NOTICE OF DECISION

CLASS 3 SITE PLAN REVIEW / CLASS 2 ADJUSTMENT / CLASS 2 DRIVEWAY APPROACH PERMIT CASE NO.: SPR-ADJ-DAP23-24

APPLICATION NO.: 22-117603-PLN

SUMMARY: Proposed new 31,814 square-foot, three-story, medical/office building with associated site improvements and off-street parking.

B EAST ELEVATION
SCALE : 1/16" = 1'-0"

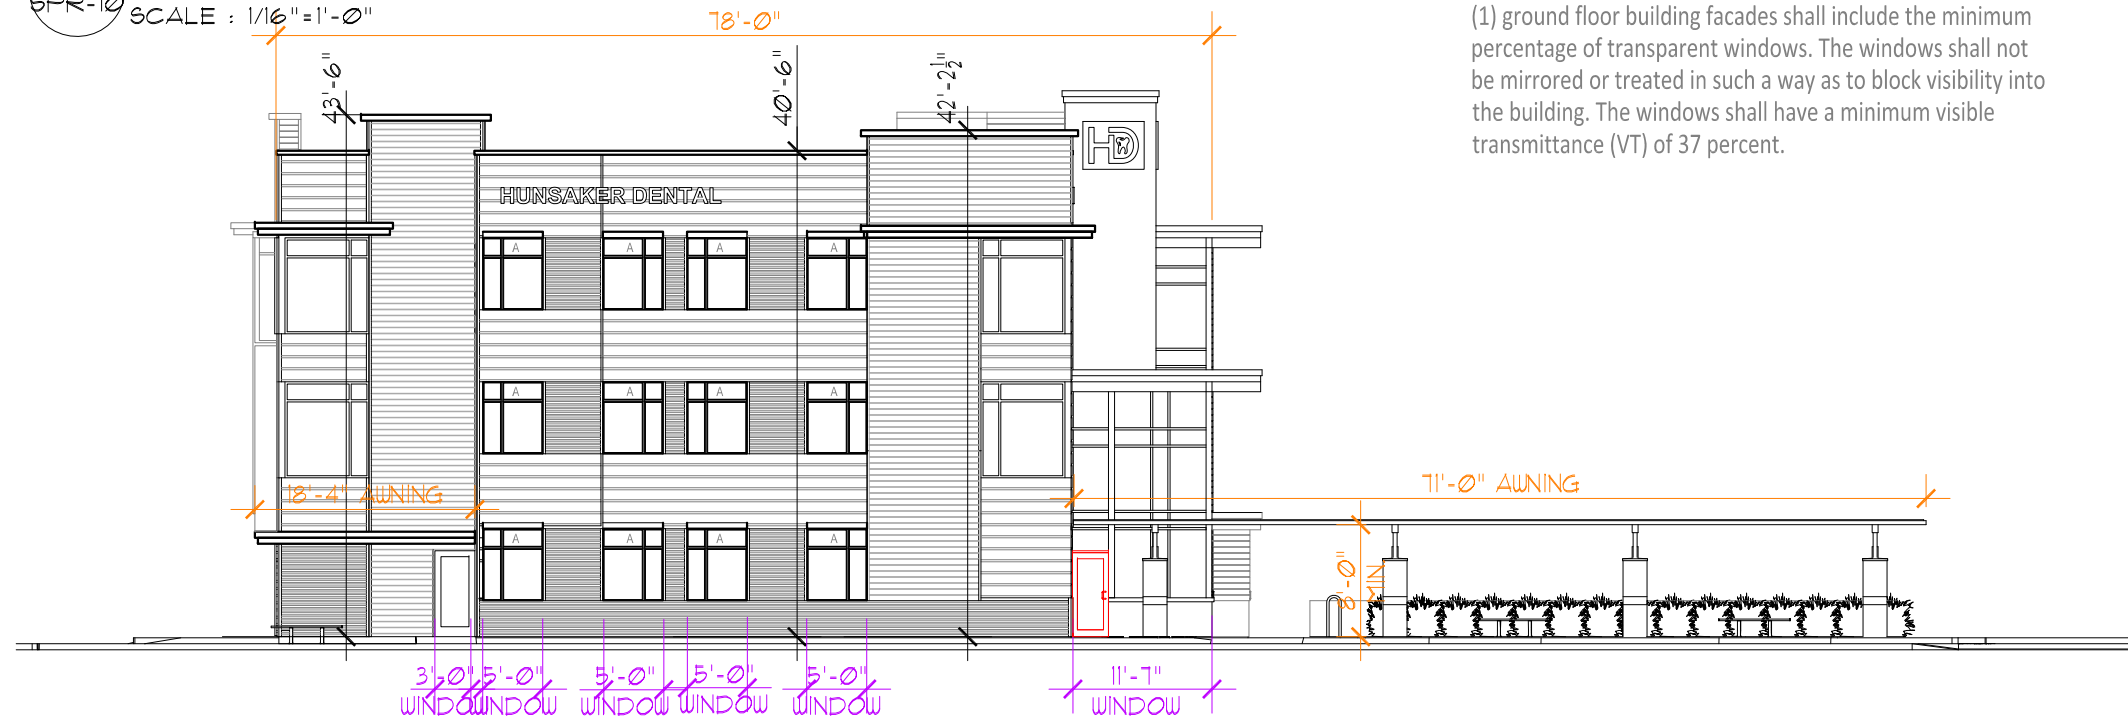
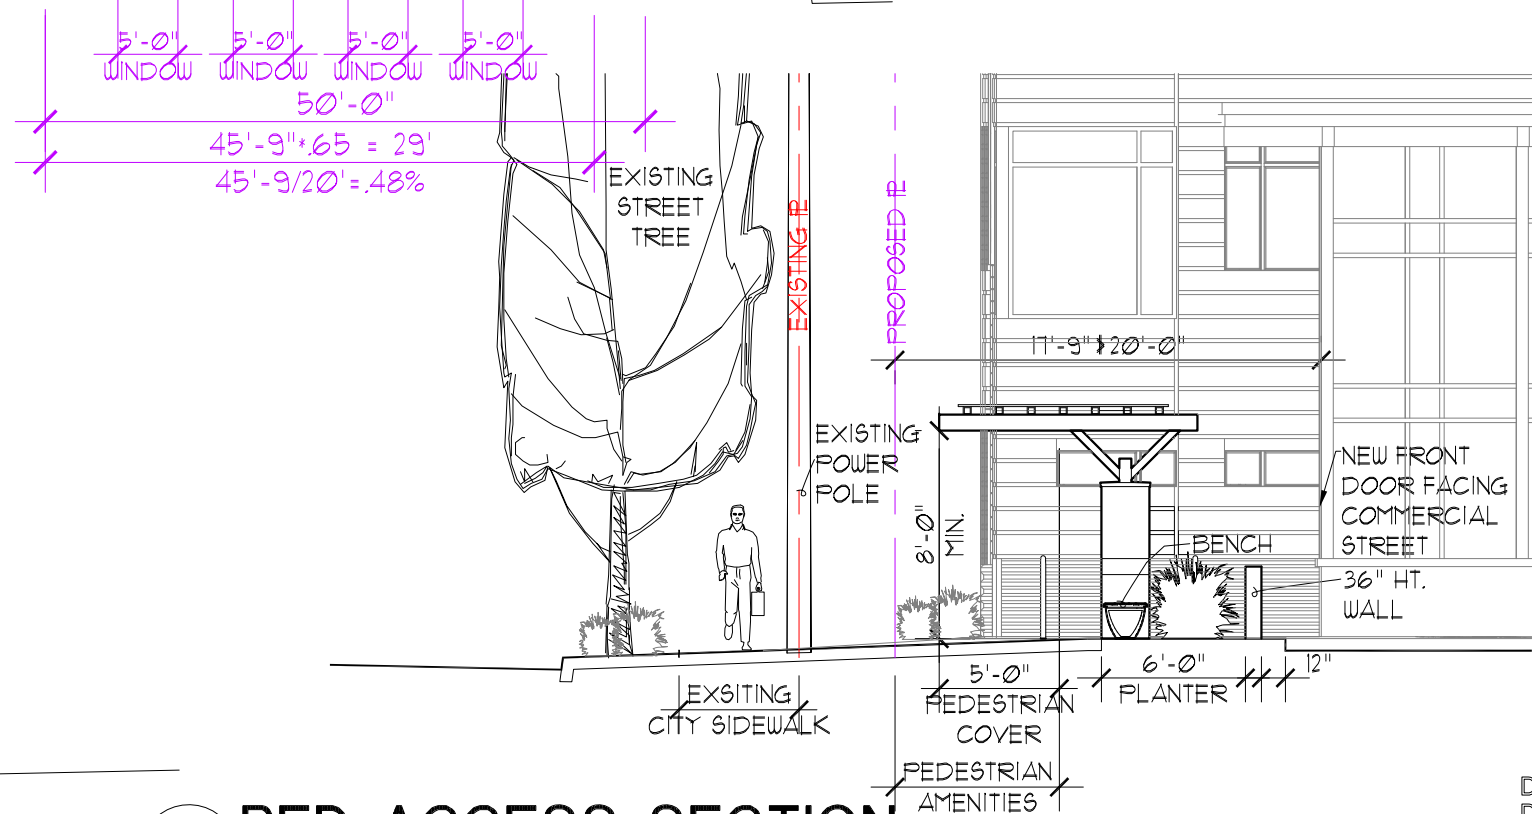
As shown on the building elevation drawings and renderings, the proposed building includes projecting sunshades above individual windows but does not include weather protection in the form of awnings or canopies along a minimum of 75 percent of the ground floor facades facing Commercial Street and Kearney Street. The building does, however, include an attached canopy structure that extends north from the building along Commercial Street to provide weather protection. The canopy structure provides a vertical clearance above the sidewalk of eight feet and projects into the public right-of-way as allowed under this standard. However, because the canopy structure does not provide weather protection along the actual ground floor façade of the building facing Commercial Street it cannot be counted towards meeting the weather protection requirement of this standard.

78' x .65 = 50.7' REQUIRED WINDOW WIDTH 34'-7" WINDOW PROVIDED
78' BUILDING WIDTH x .75 = 58.5' REQUIRED AWNING WIDTH 89'-4" AWNING WIDTH PROVIDED

PROPOSED
SITE PLAN

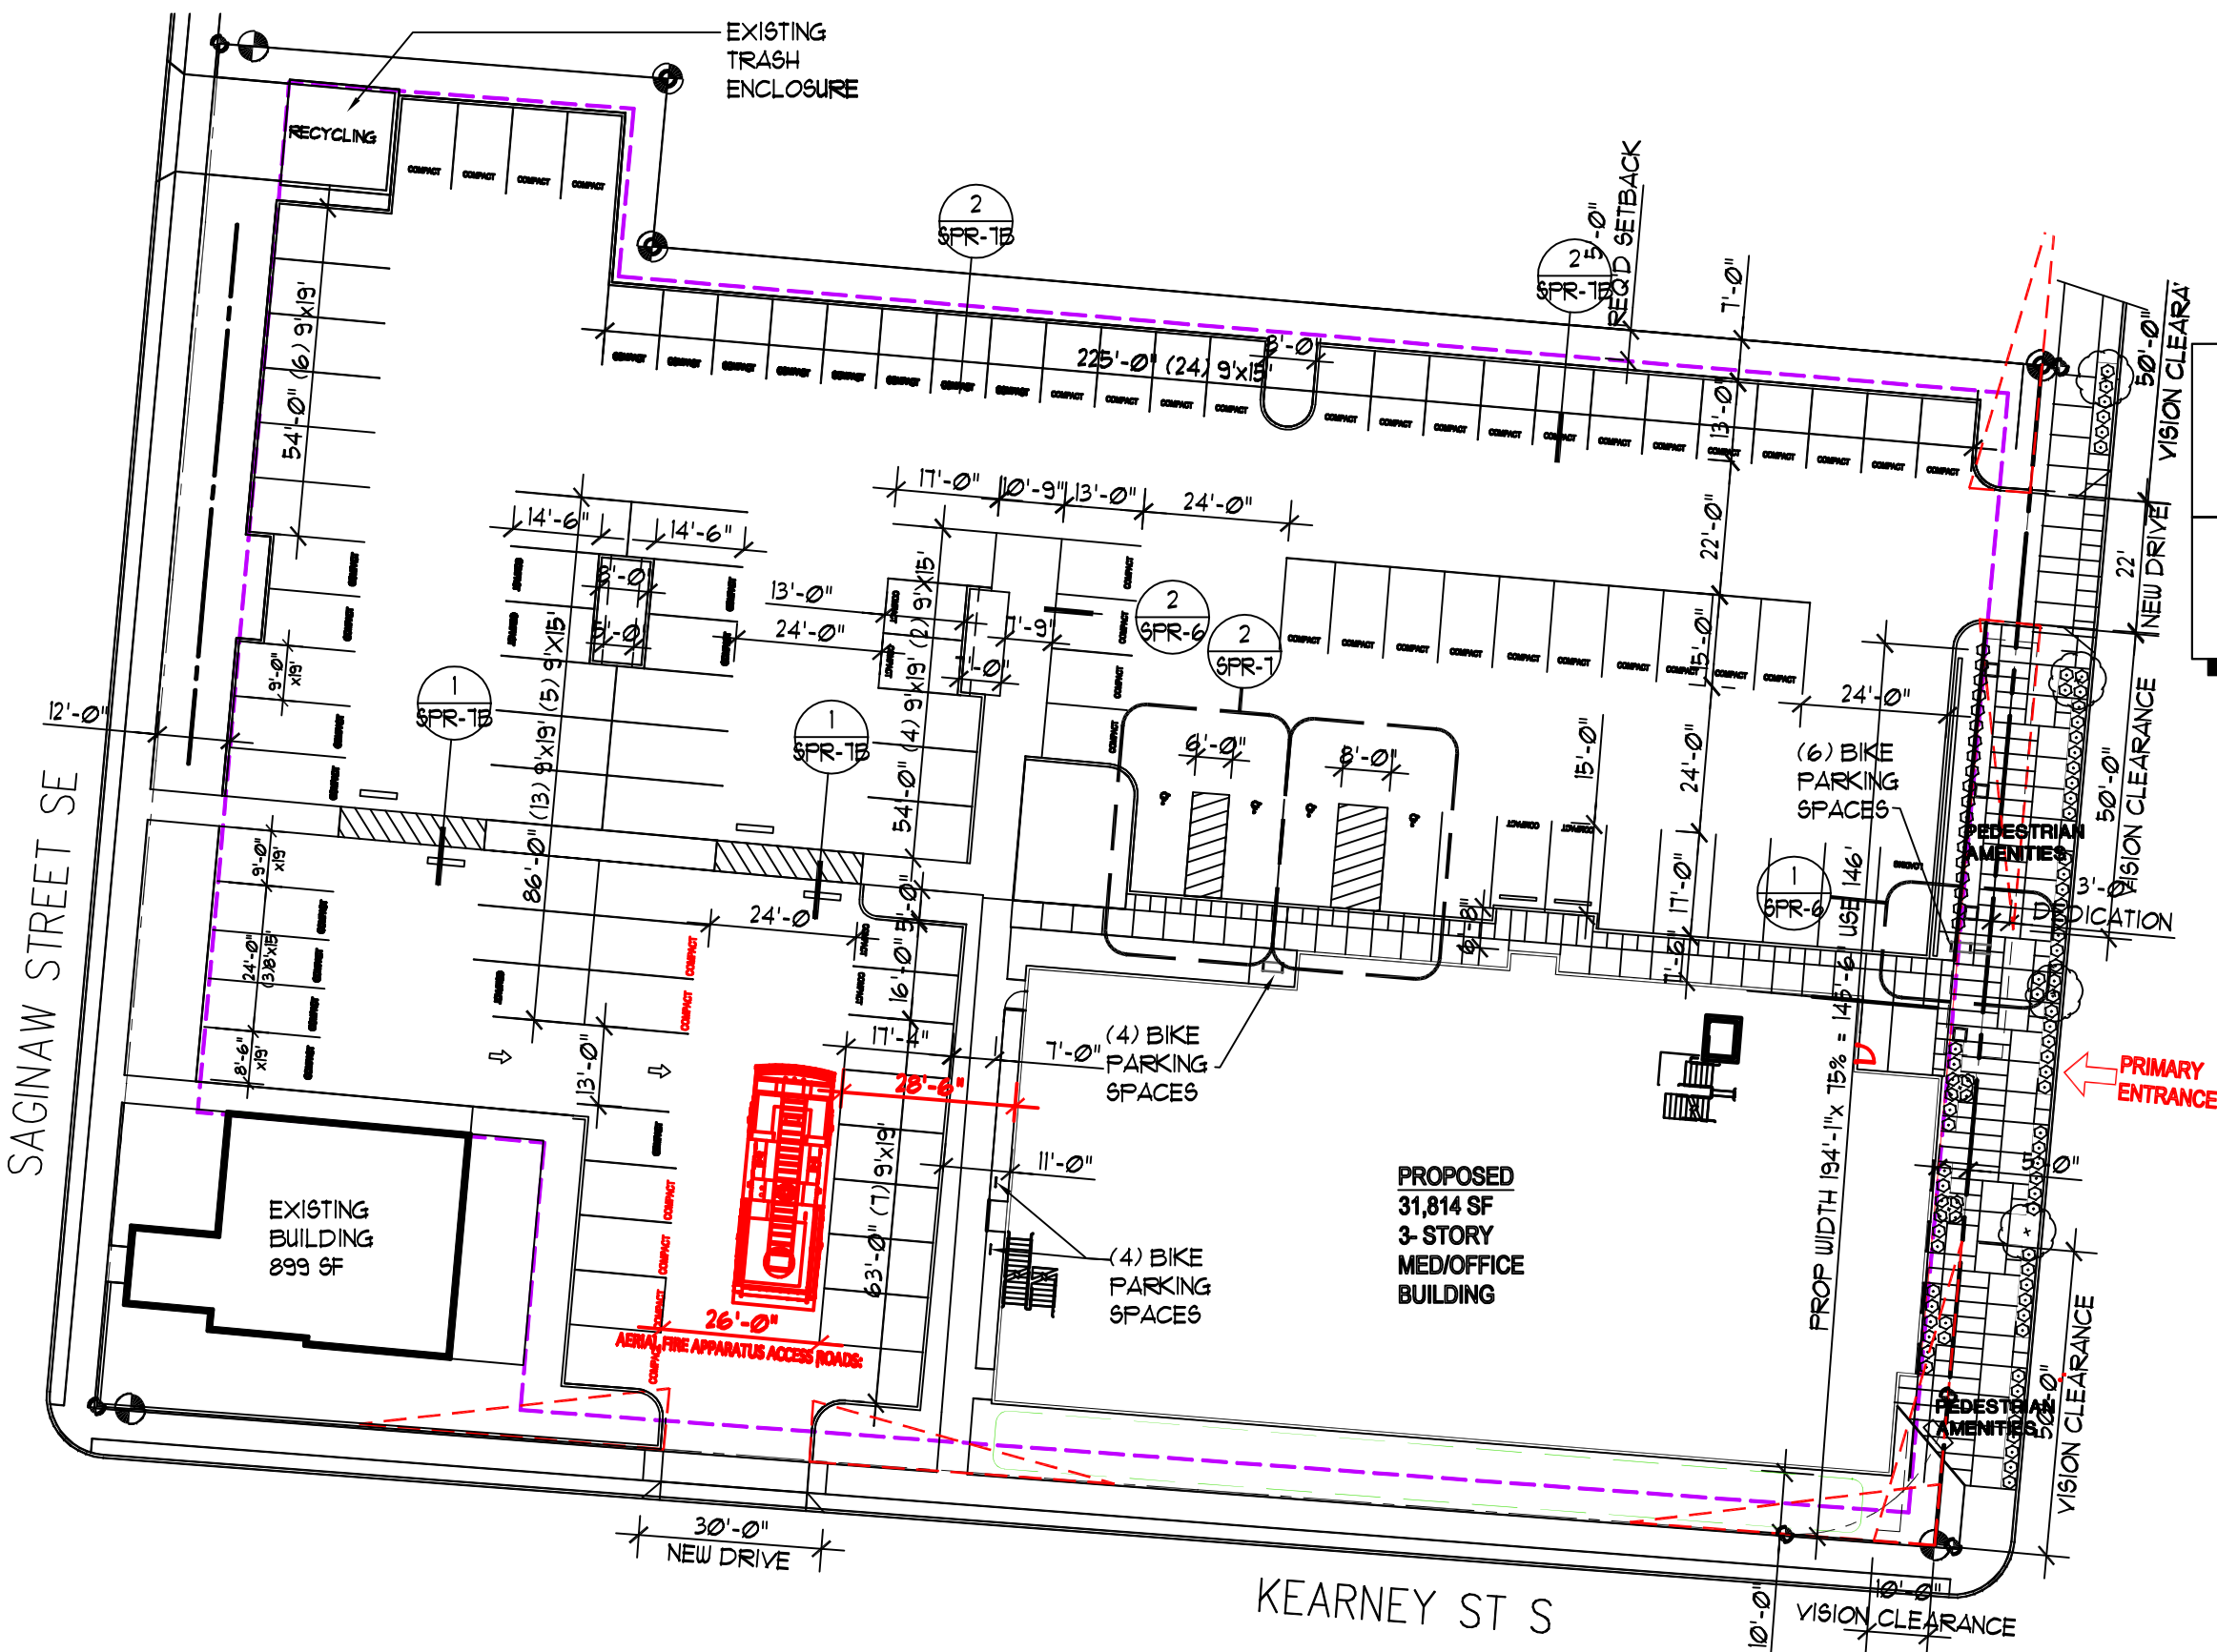
Staff Response: Because the proposed new building will be over 30 feet in height, fire department aerial access to the building is required. In order to accommodate fire department aerial fire access, the proposed parking lot drive aisle adjacent to the west side of the building is required to be widened to a minimum width of 26 feet.

In order to comply with fire department access requirements the applicant submitted a revised site plan which increases the width of the parking lot drive aisle along the west side of the building to 26 feet. In order to ensure that fire department aerial access requirements are met, the following condition of approval shall apply:

Condition 1: In order to accommodate fire department aerial access, the parking lot drive aisle adjacent to the west side of the proposed building shall be widened to a minimum width of 26 feet as shown on the revised site plan included as Attachment I to this decision.
